Service Issue Alert

Equipment: LDK6000 7" viewfinder

Area of modification

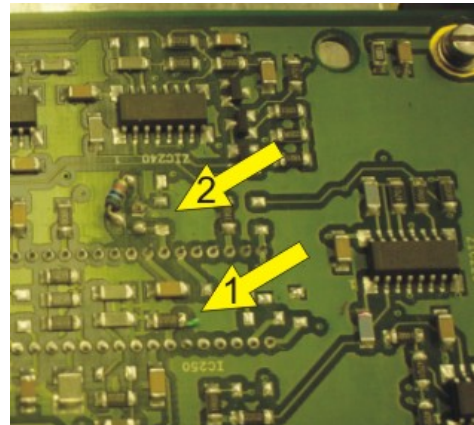
Problem : Picture is stretched vertically.

Description of Remedy: remove modification

Remedy: Remove cover to gain access to circuit board or right side of viewfinder. As shown below

Remove green kynar wire at location 1
Remove transistor at location 2
Picture shows modification removed

*If the transistor or jumper is already removed and the problem persists, the problem is caused by another fault
